DOWNERS ROCK SUBDIVISION

APPLICATION NUMBER 2 DATE December 21, 2017

DETAIL SITE PLAN

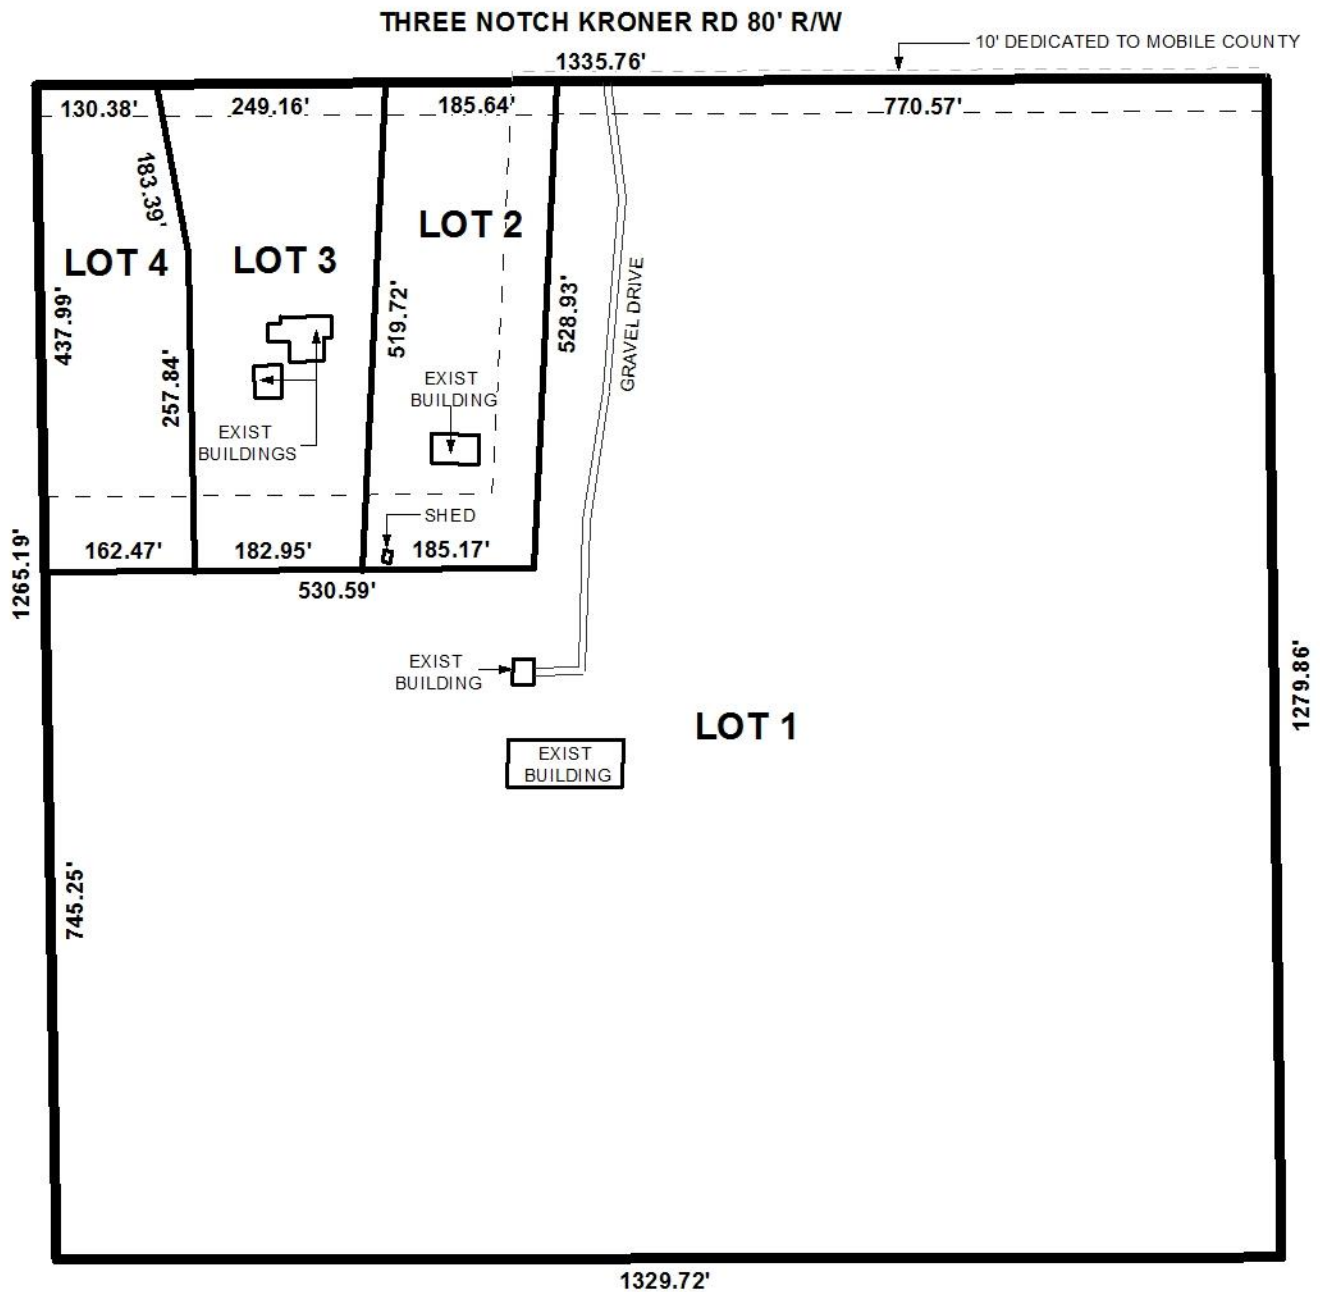
The proposed lots meet the minimum lot size requirements and are labeled in square feet and acres. However, the proposed lots are identified as parcels instead of lots. The plat should be revised to depict each lot with an associated lot number as well as the total square footage in square feet and acres.

The proposed lots front Three Notch Kroner Road. Three Notch Kroner Road is a Major Collector street without curb and gutter. As a Major Street, this street requires a 100' wide right-of-way width. The right-of-way width is depicted as 90' on the preliminary plat, with a note illustrating 10' of dedication to Mobile County. The additional dedication will result in a total of 50' of right-of-way from the centerline.

The plat depicts a 35' minimum building setback line. The 35' minimum building setback line should be retained on the Final Plat, if approved.

As a means of access management, a note should be placed on the Final Plat stating that Lot 1 will be limited to two curb-cuts to Three Notch Kroner Road, and Lots 2 through 4 will be limited to one curb-cut each to Three Notch Kroner Road, with any changes to the size, design and location of the curb-cuts to be approved by Mobile County Engineering and conform to AASHTO standards.

- 1. revision of the plat to depict each lot with an associated lot number as well as the total square footage in square feet and acres;*
- 2. retention of the 35' minimum building setback lines;*

- 3. dedication to provide 50' from centerline of Three Notch Korner, as depicted;*
- 4. placement of a note on the Final Plat stating Lot 1 will be limited to two curb-cuts to Three Notch Kroner Road, and Lots 2 through 4 will be limited to one curb-cut each to Three Notch Kroner Road, with any changes to the size, design and location of the curb-cuts to be approved by Mobile County Engineering and conform to AASHTO standards;*

- 5. placement of a note on the Final Plat stating that any lots which are developed commercially and adjoin residentially developed property must provide a buffer, in compliance with Section V.A.8. of the Subdivision Regulations;*
